# DYER WHARF I-195 DESIGN PRESENTATION

2.2.2026

**CV Properties** LLC  
DEVELOPMENT + INVESTMENT + MANAGEMENT

# WAIVER 5 CRITICAL SYSTEMS MEETING DESIGN FLOOD ELEVATION 2 (DFE-2):

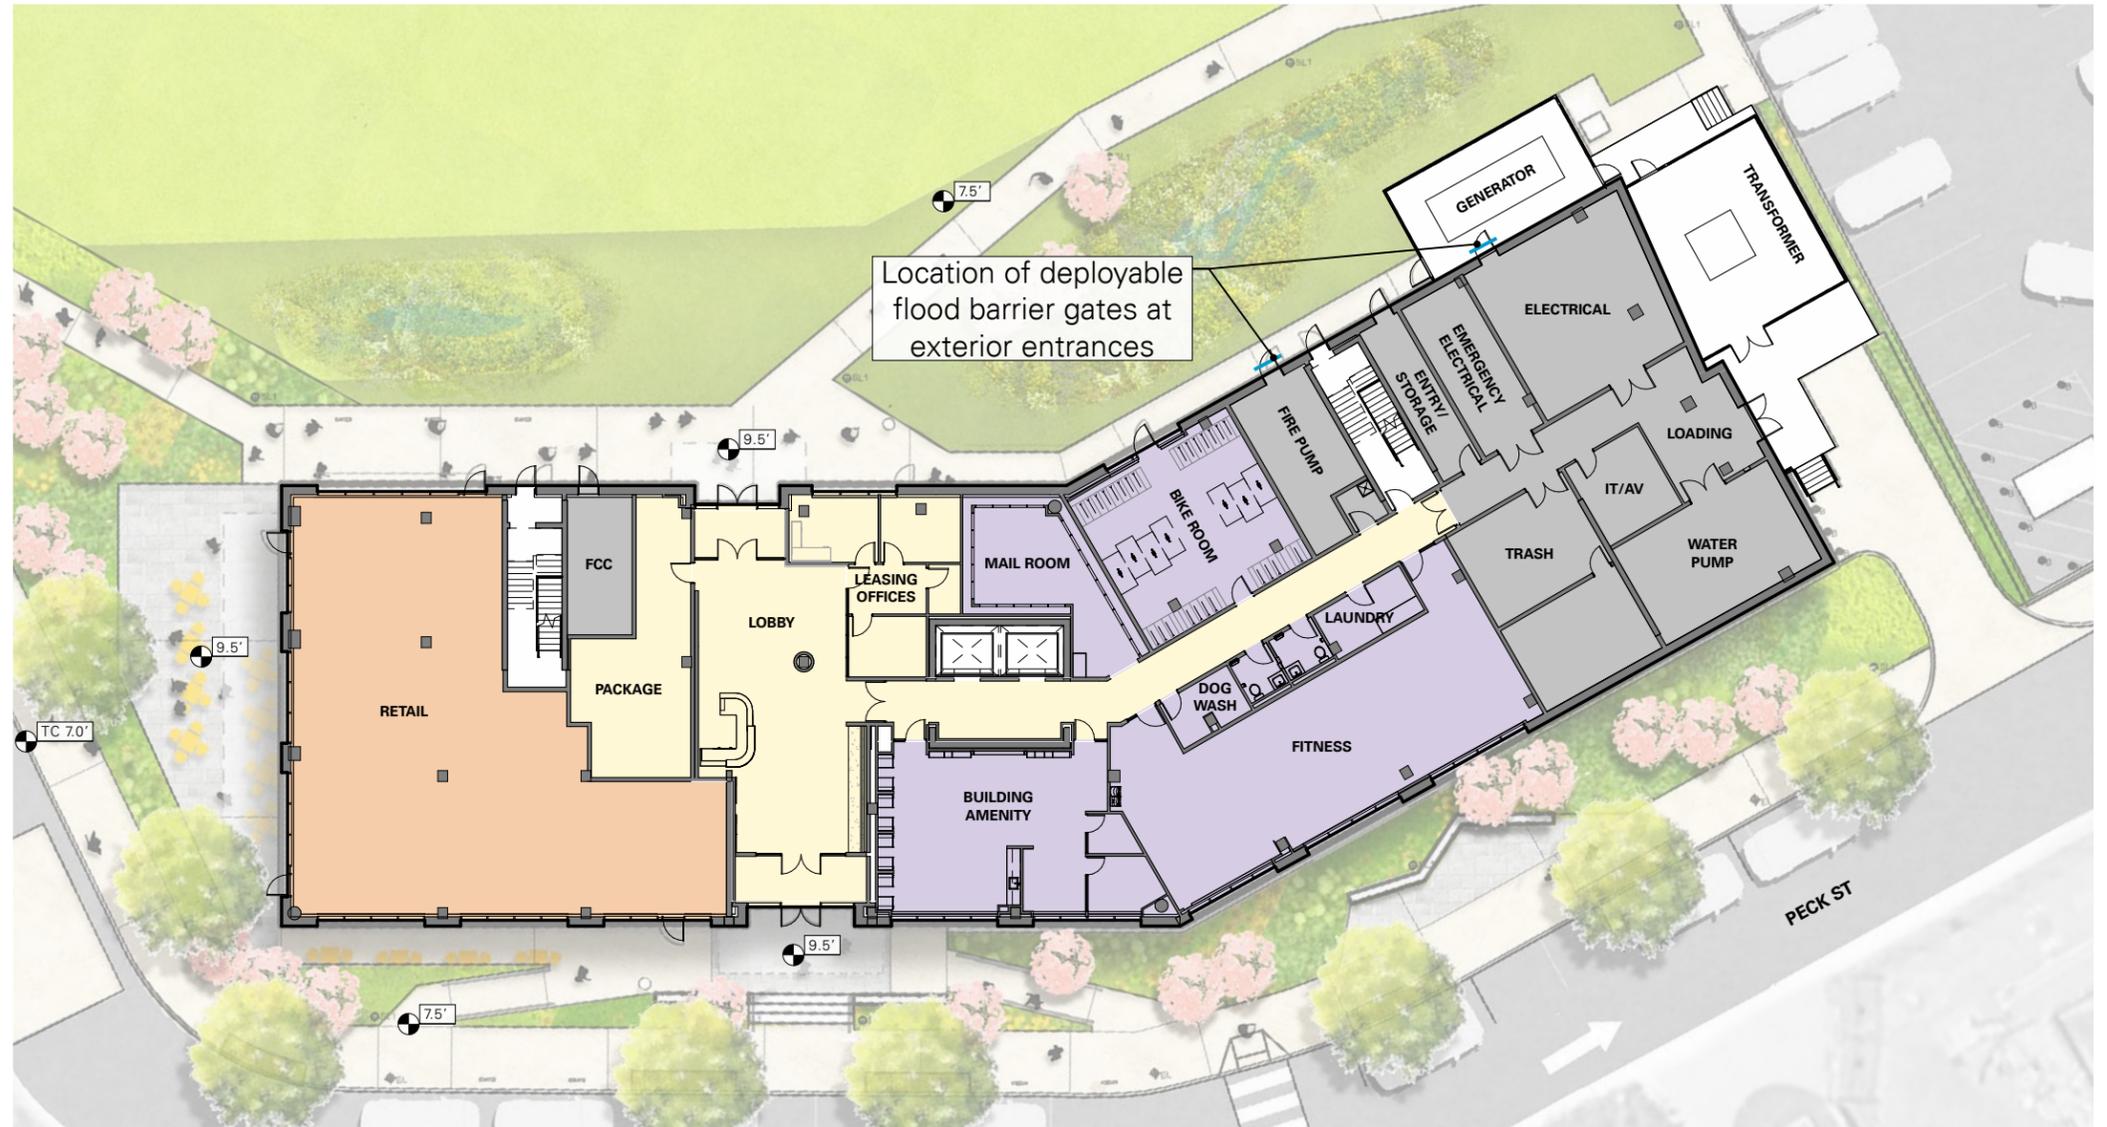
2.6 FLOOD RESILIENCE STANDARDS, SECTION 2.6.C.2

ALLOW CRITICAL MECHANICAL AND ELECTRICAL SYSTEMS TO BE LOCATED AT ELEVATIONS BELOW DFE-2, PROVIDED THAT DEPLOYABLE DRY FLOODPROOFING BARRIERS ARE INCORPORATED INTO THE DESIGN SUCH THAT THEY PROTECT THE MAIN ELECTRICAL EQUIPMENT, THE EMERGENCY ELECTRICAL EQUIPMENT, THE FIRE PUMP EQUIPMENT, IT/ AV EQUIPMENT AND CENTRALIZED WATER SYSTEM, AND THE EXTERIOR PAD MOUNTED ELECTRICAL TRANSFORMER AND GENERATOR FROM FLOOD DAMAGE TO THE MAXIMUM DEGREE ALLOWABLE BY RI ENERGY.

# WAIVER 6 HEIGHT OF FENCES AND WALLS

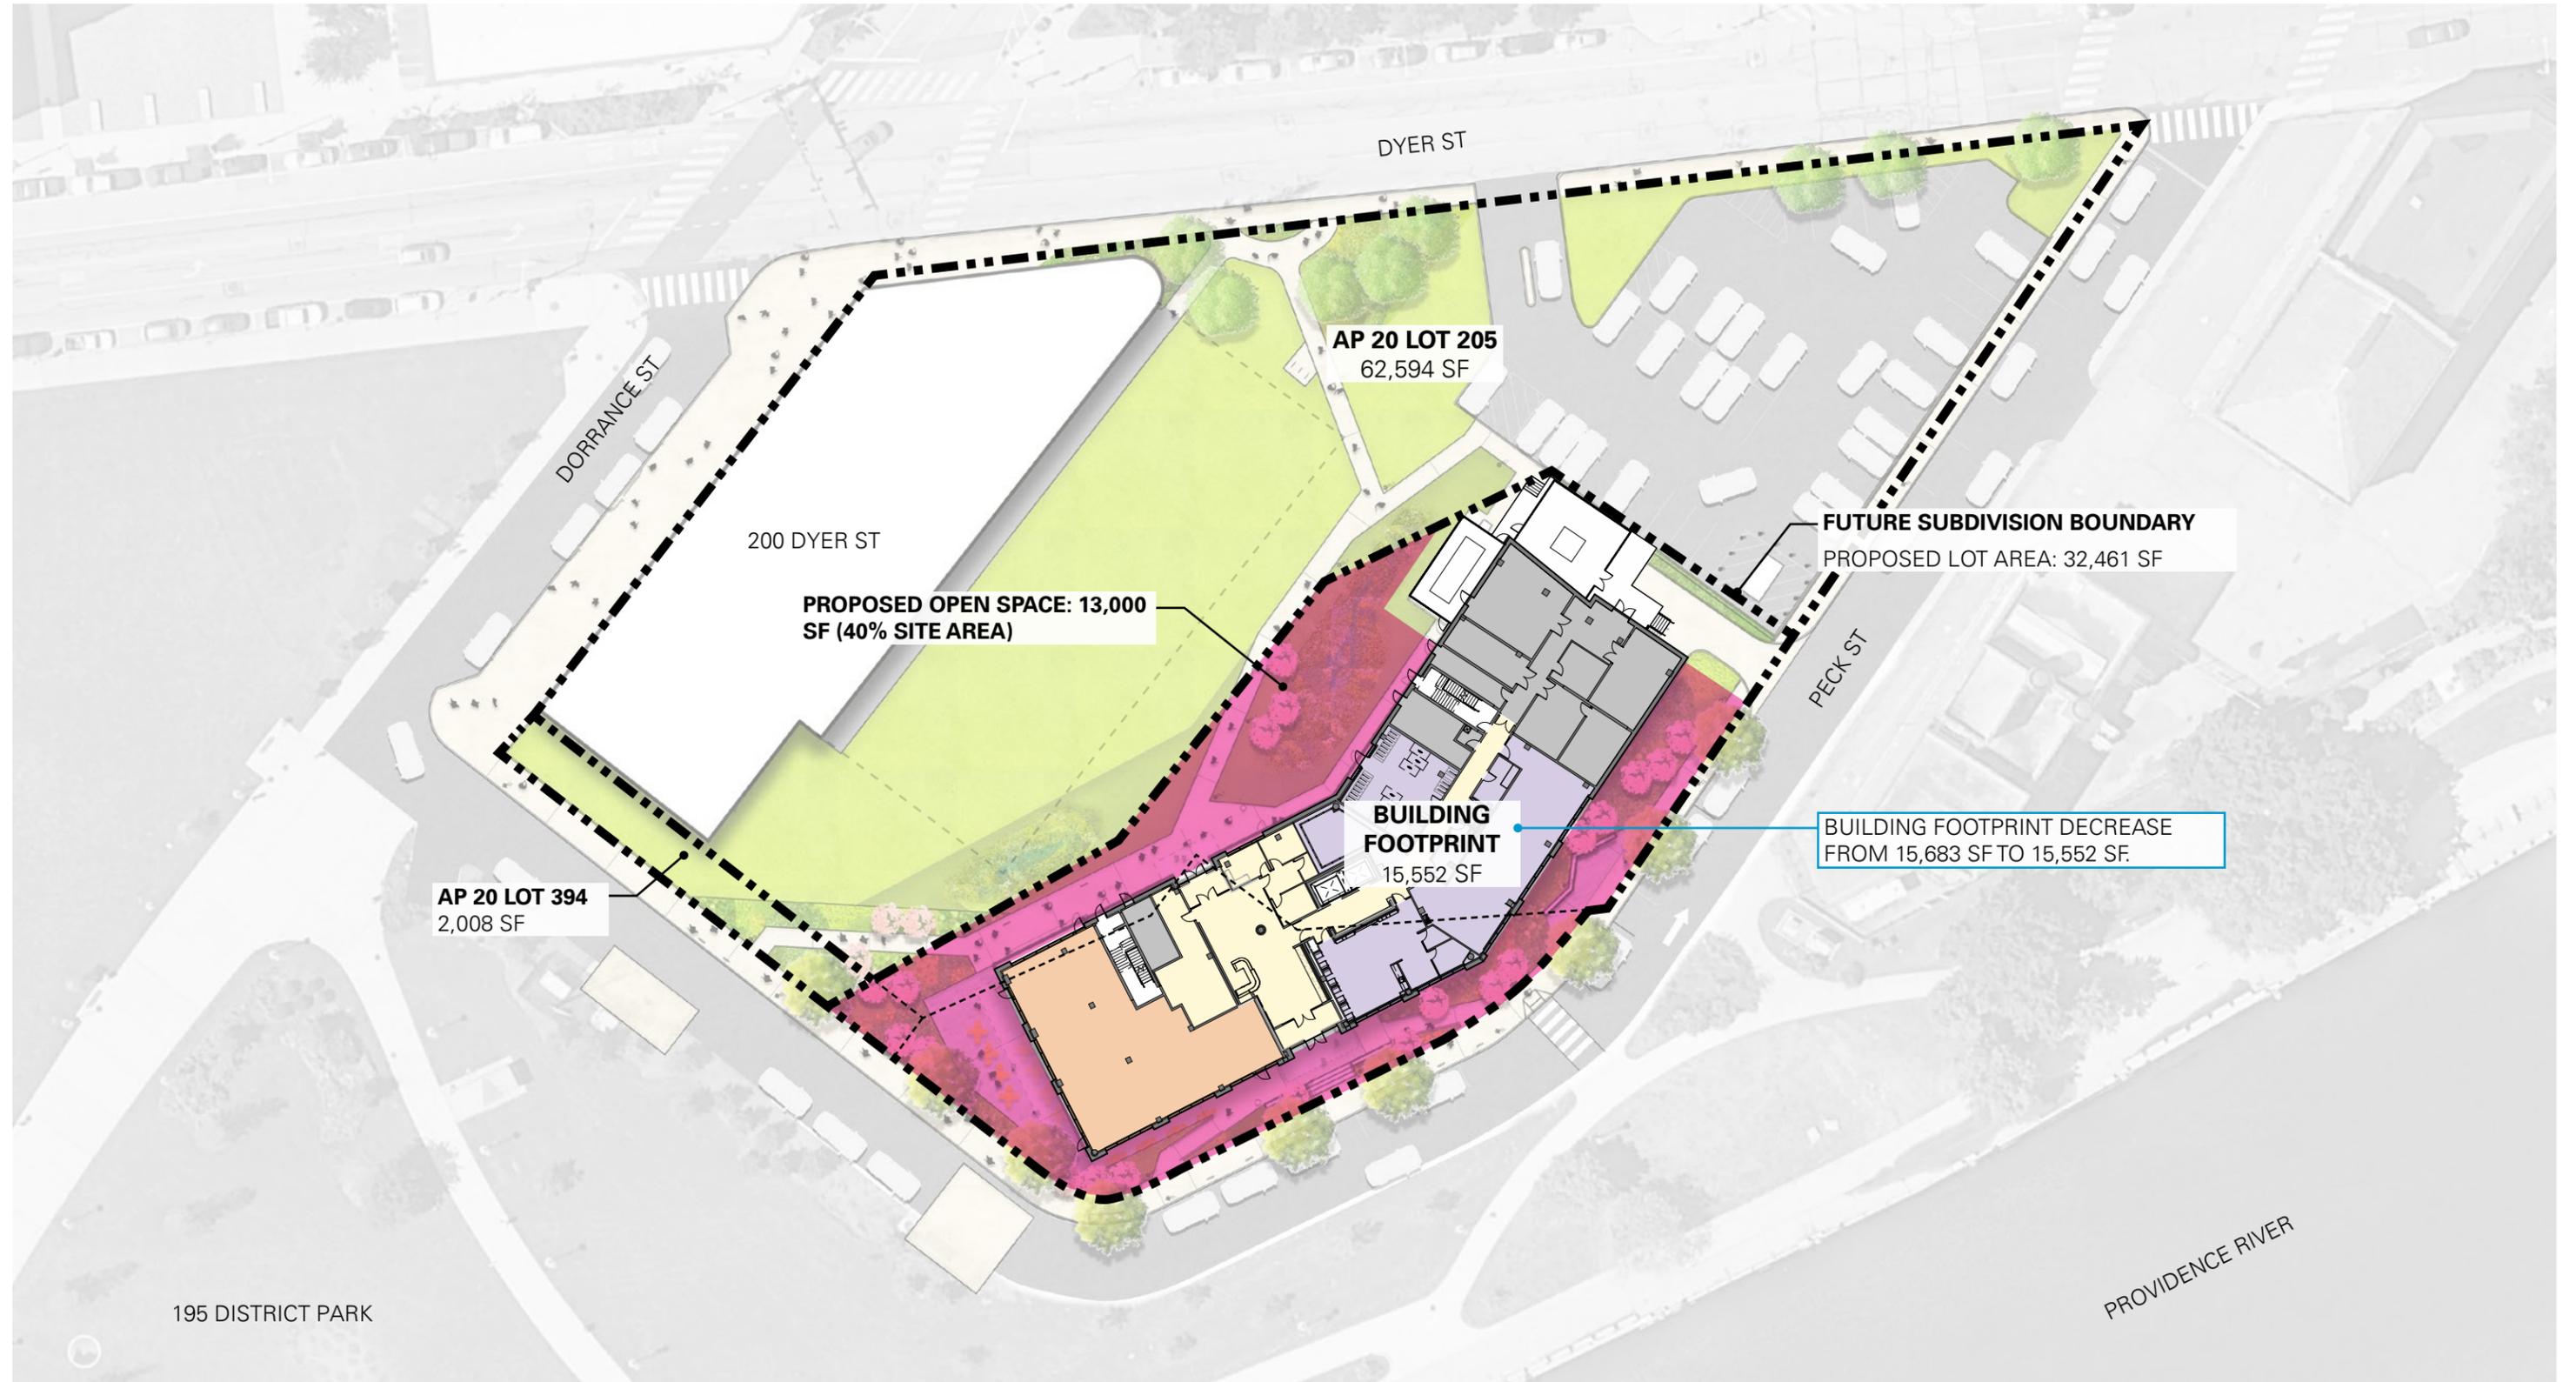
### 2.7 SITE IMPROVEMENTS, SECTION 2.7.B.1

SCREENING OF THE GROUND-MOUNTED TRANSFORMER AND GENERATOR IS ALLOWABLE UP TO THE MINIMUM HEIGHT NECESSARY TO SCREEN THE EQUIPMENT FROM PUBLIC VIEW AT EYE-HEIGHT FOR PEDESTRIANS STANDING ON PUBLIC RIGHTS OF WAYS AND WALKWAYS ABUTTING THE EQUIPMENT.

# FACADE COMPARISON WEST ELEVATION GROUND LEVEL DESIGN

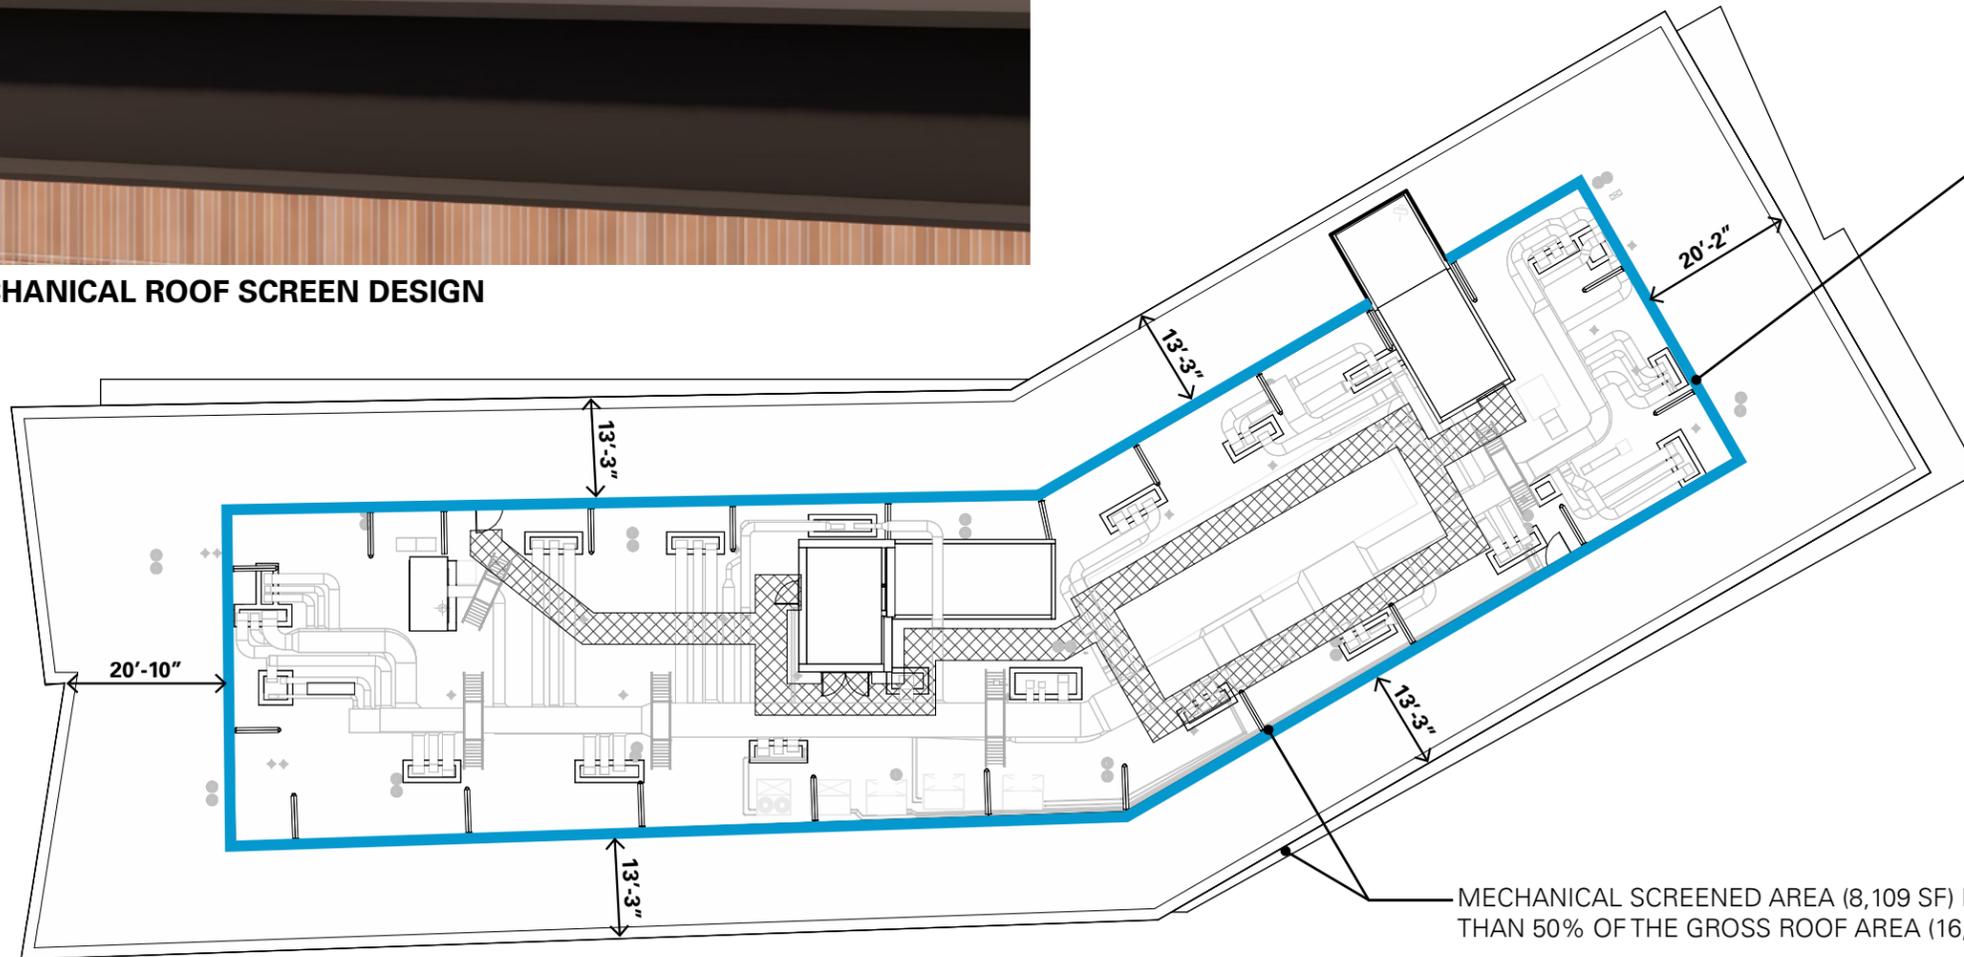
PROPOSED DESIGN

# ROOF SCREEN

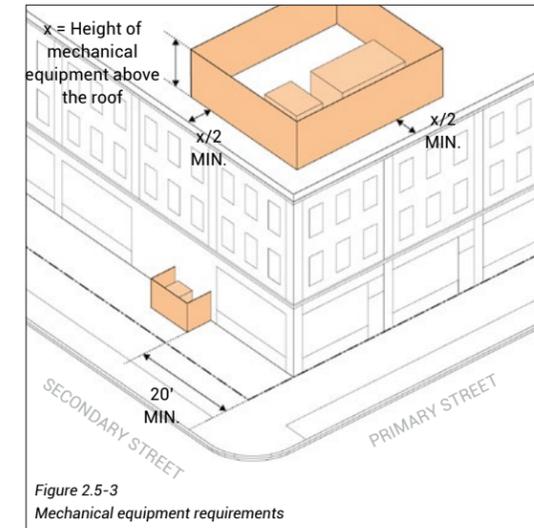
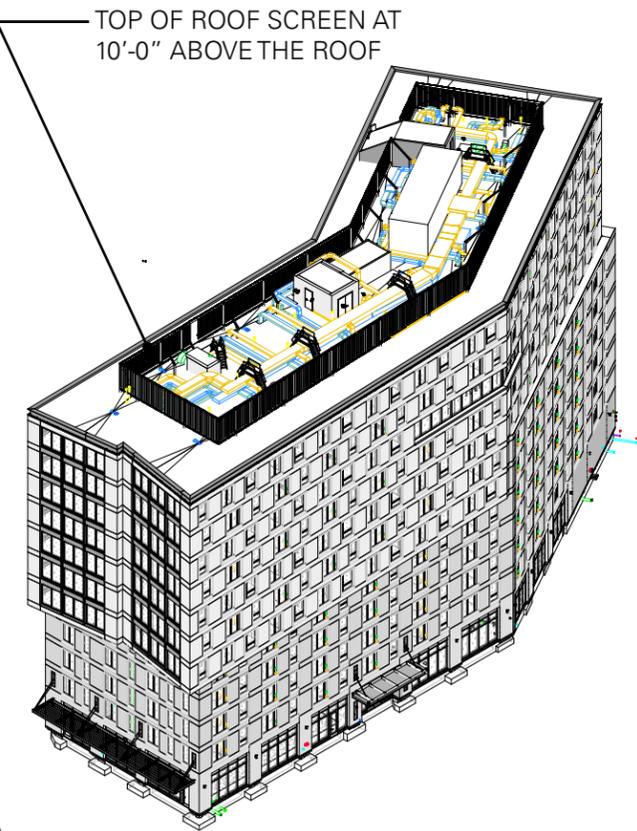
CURRENT DESIGN REMOVES PERFORATIONS IN METAL ROOF SCREEN SHOWN IN 02.19.2025 I-195 PRESENTATION

MECHANICAL SCREENED AREA (8,109 SF) IS LESS THAN 50% OF THE GROSS ROOF AREA (16,229 SF)

PREVIOUS MECHANICAL SCREENED AREA (7,781 SF)

TOP OF ROOF SCREEN AT 10'-0" ABOVE THE ROOF

# FACADE DESIGN MATERIAL PALETTE

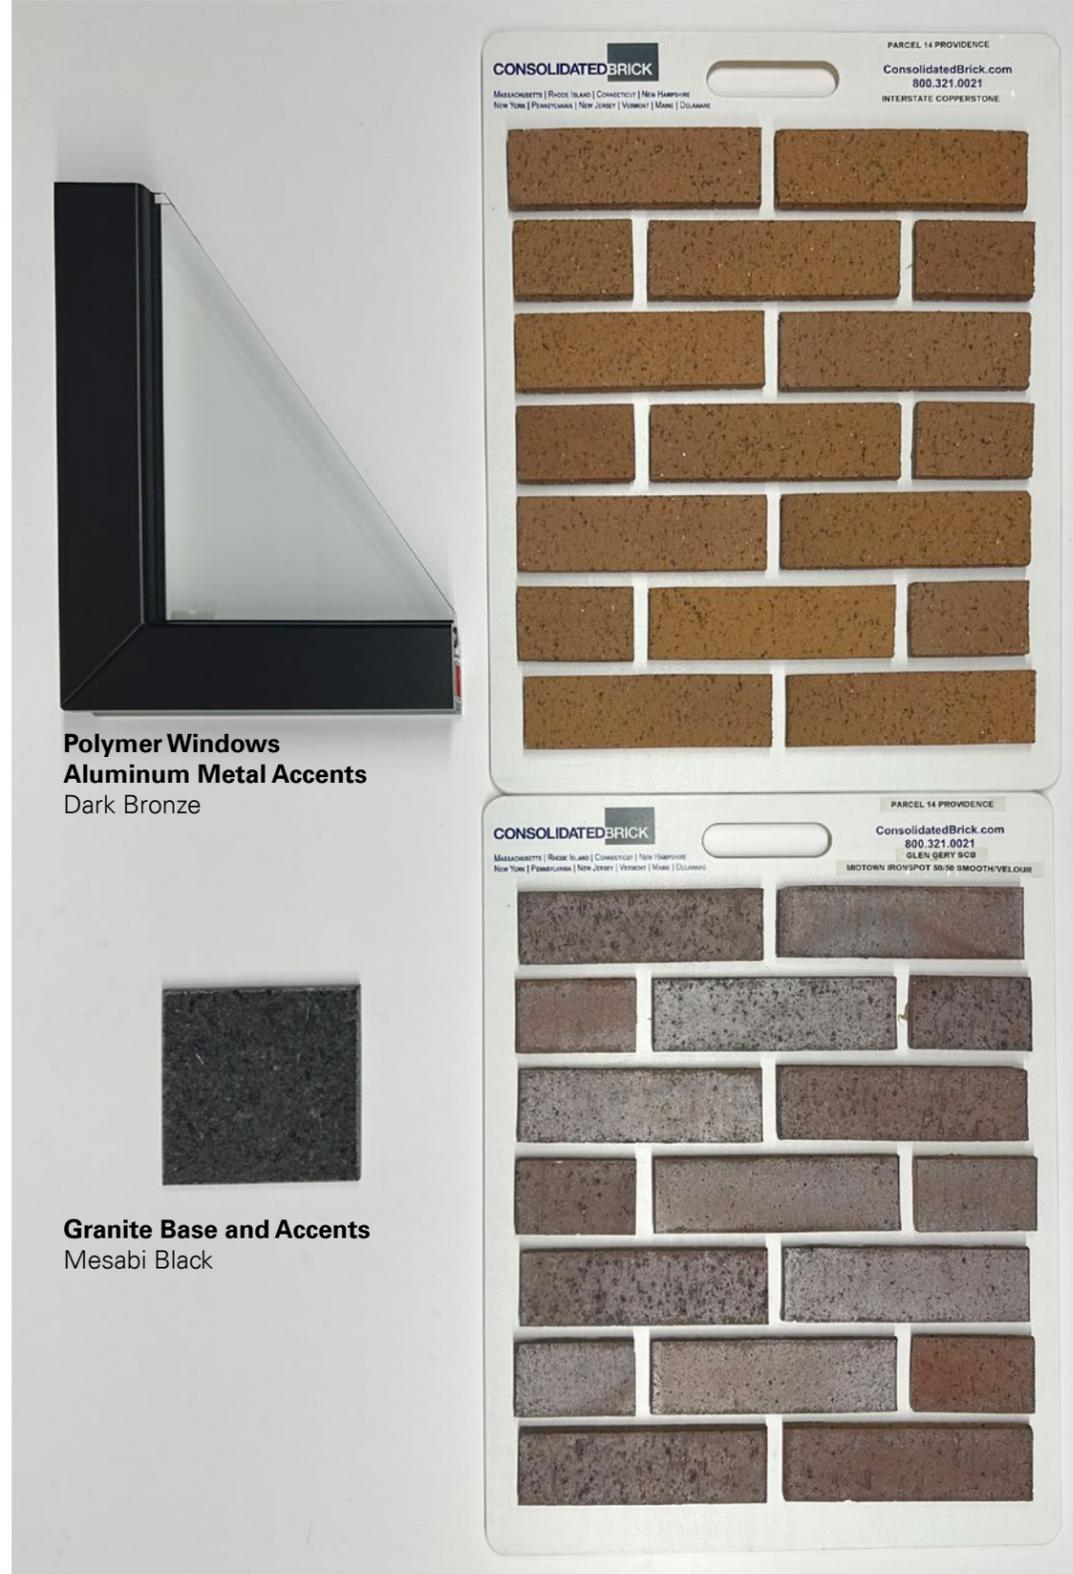
**Polymer Windows**  
**Aluminum Metal Accents**  
Dark Bronze

**Granite Base and Accents**  
Mesabi Black

**Upper Brick**  
Interstate Brick - Copperstone

**Lower Brick**  
Glen-Gery - Midtown Ironspot
